**TOWN OF MANCHESTER
PLANNING AND ZONING COMMISSION**

May 20, 2024
7:00 P.M.

RE: Vessel Technologies
Zoning Regulation Amendment (REG-0003-2024)

RE: Trivik Builders, LLC – 27 Lillian Drive
PRD Detailed Site Plan Modification (PRD-0001-2024)

**IMPROVEMENT LOCATION SURVEY
RECORD DRAWING
AS-BUILT PLAN PREPARED FOR
TRIVIK BUILDERS, LLC
27 LILLIAN DRIVE
MANCHESTER, CONNECTICUT**

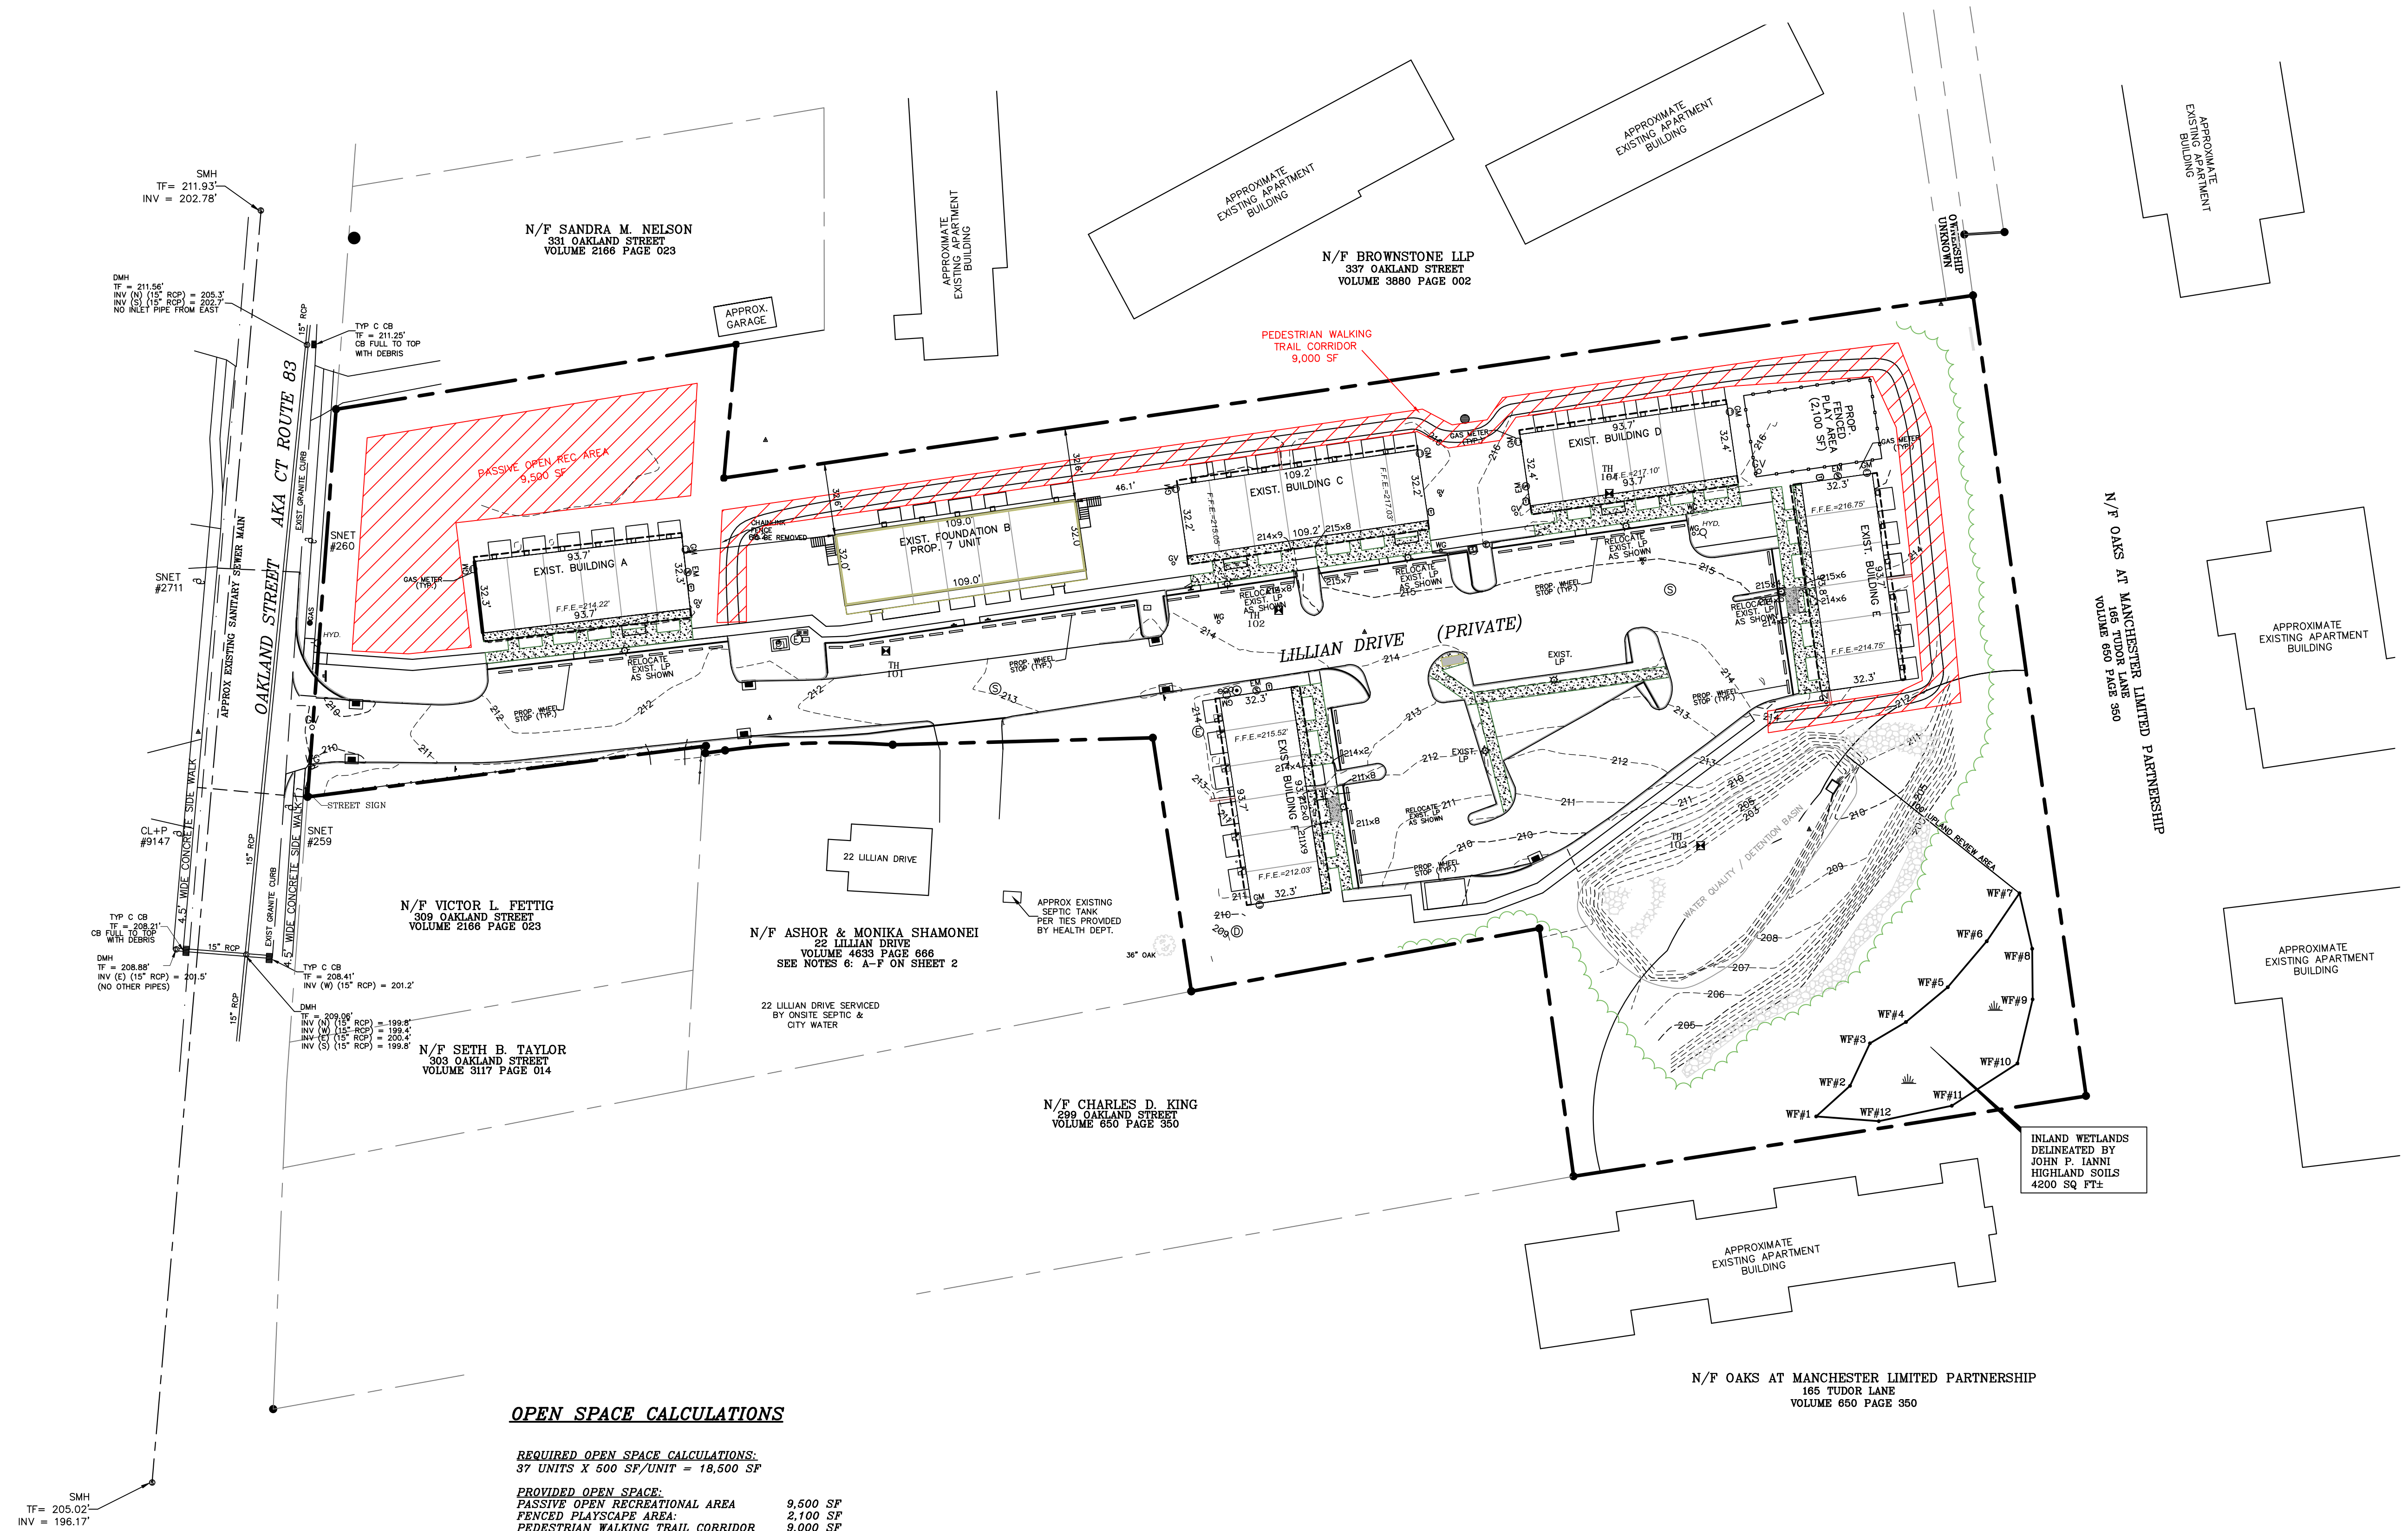
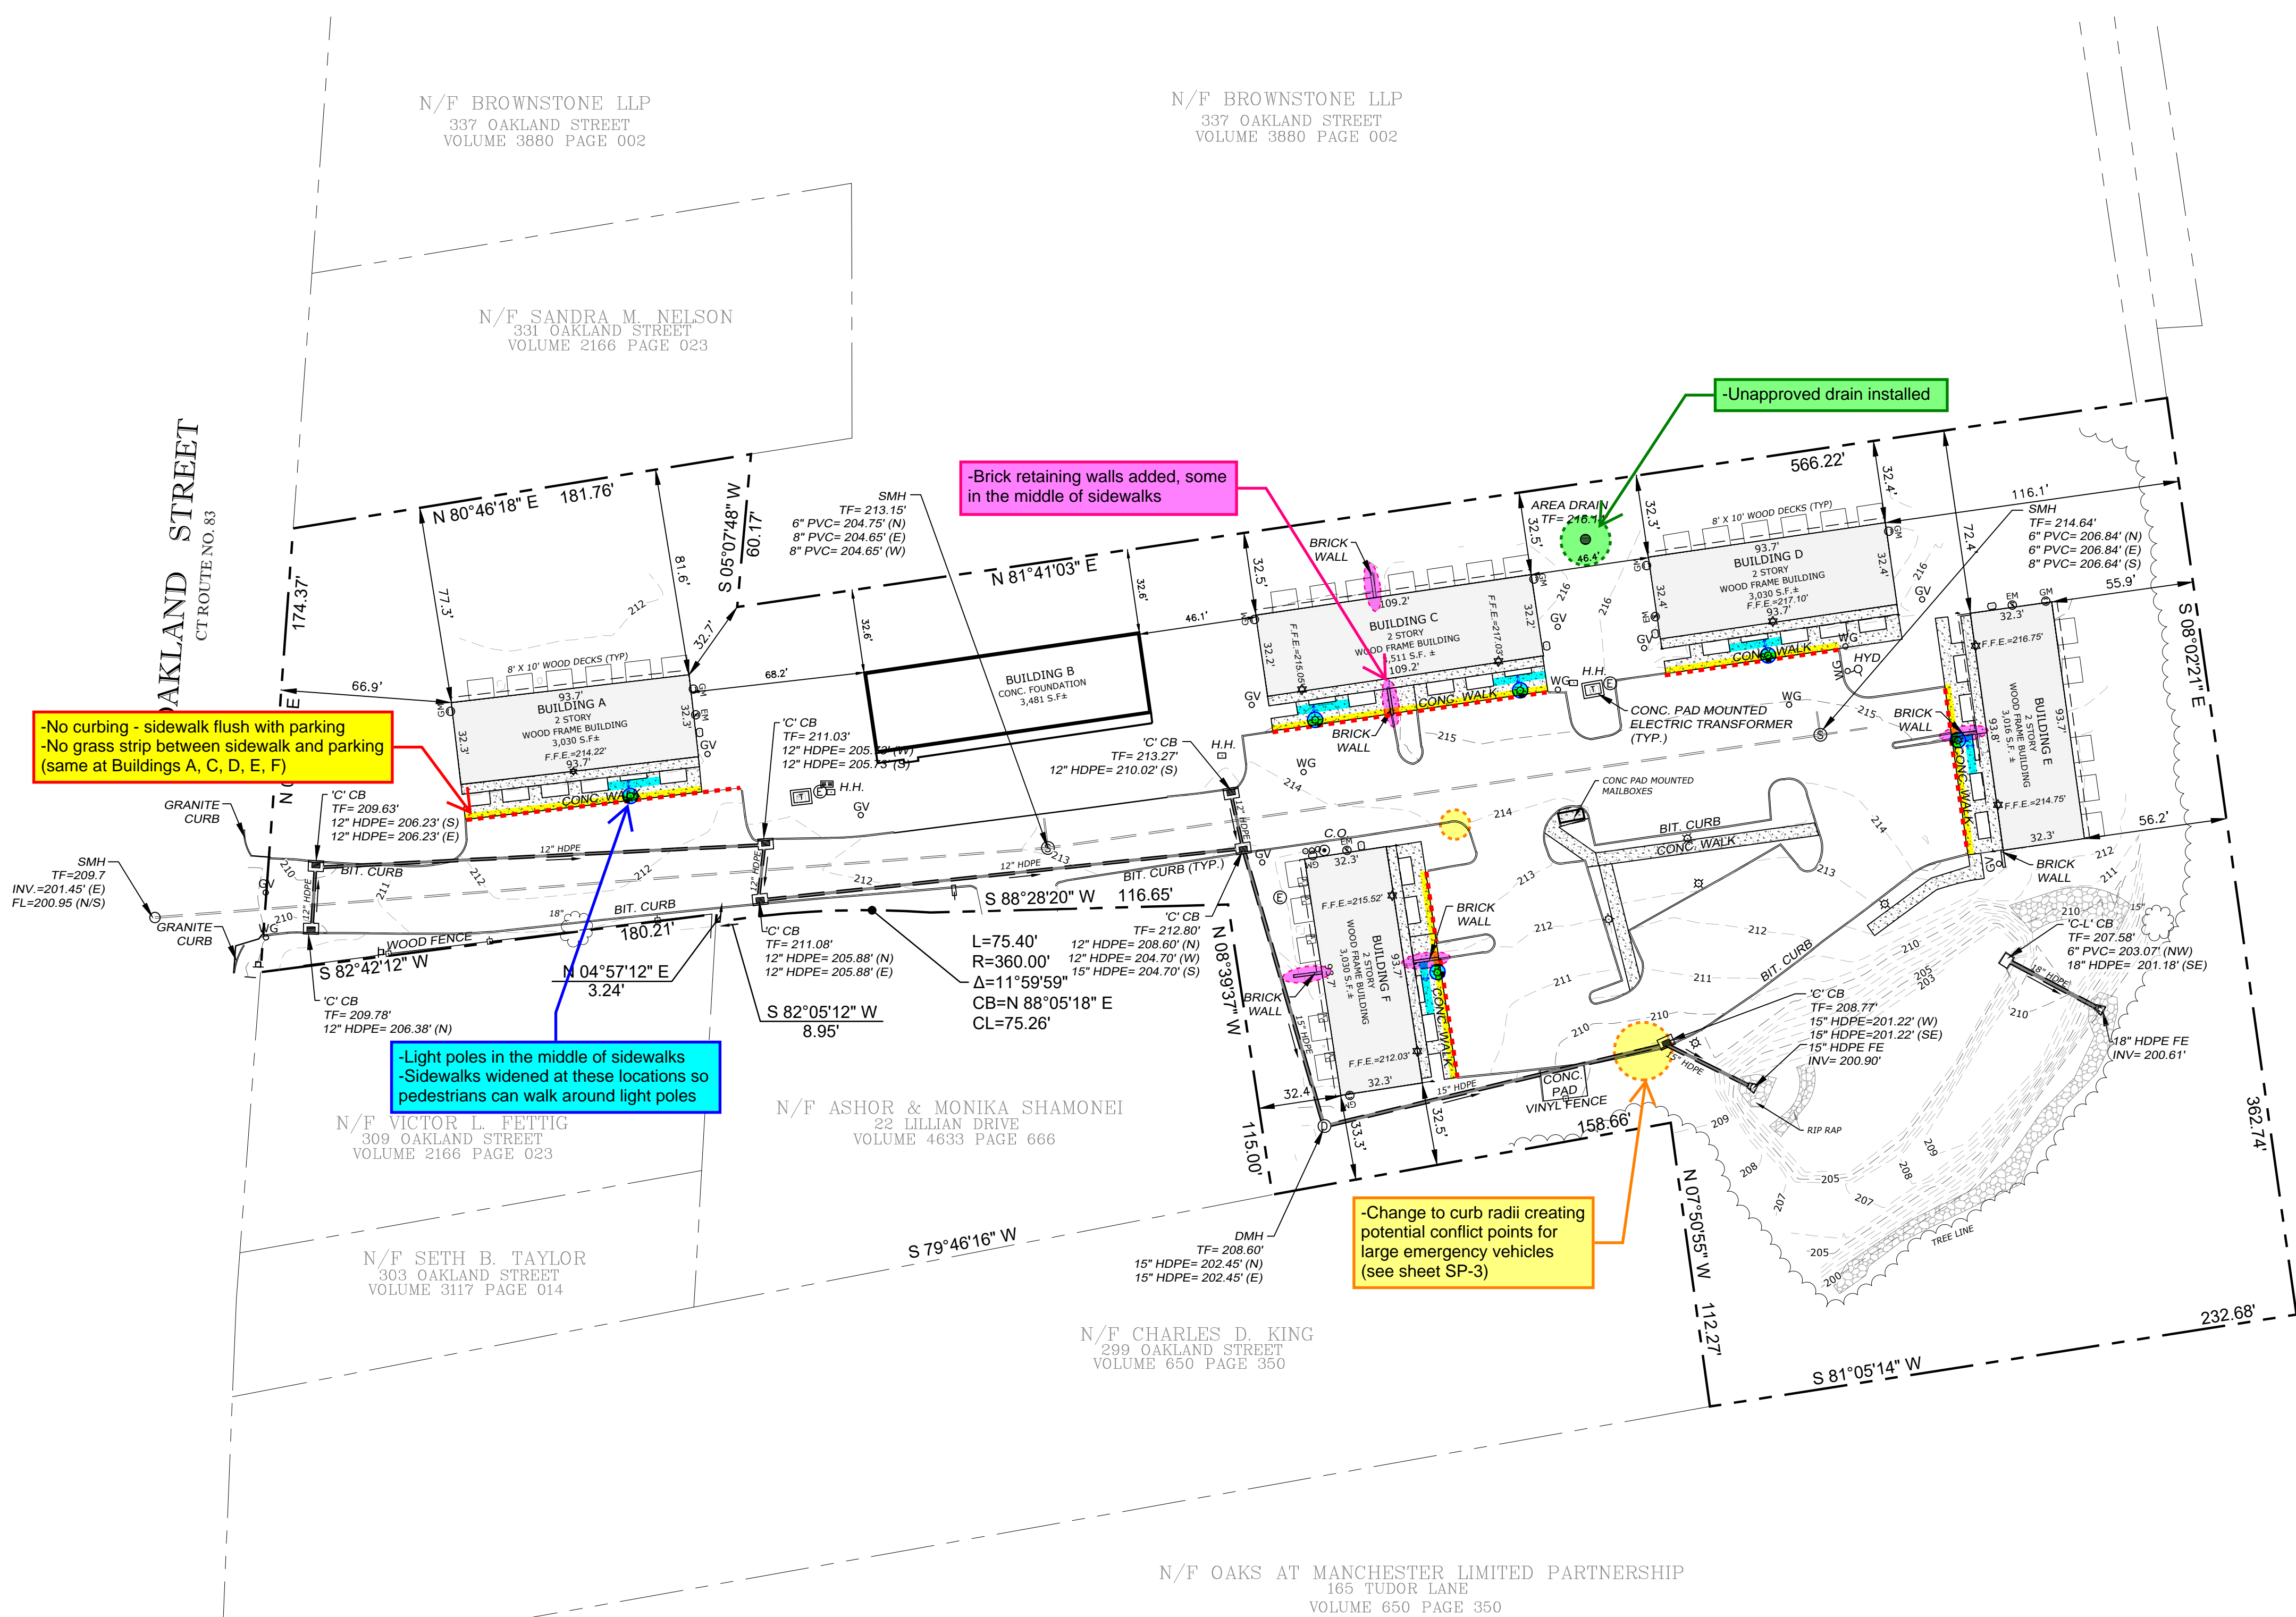
The most significant deviations from the approved plans are highlighted on the As-Built Plan sheet included in the attached plan set. These include:

- Changes to the radii of curves in the drive aisle have resulted in potential conflict points for large emergency vehicles.
- Unapproved stormwater infrastructure was installed (see highlighted area on sheet SP-4).
- Brick retaining walls were constructed in several locations at Buildings C, E, and F to remedy grading issues in the field. Several of these retaining walls block the pedestrian sidewalks.

As-built survey as of 1/15/24 with the most significant deviations from approved plans noted
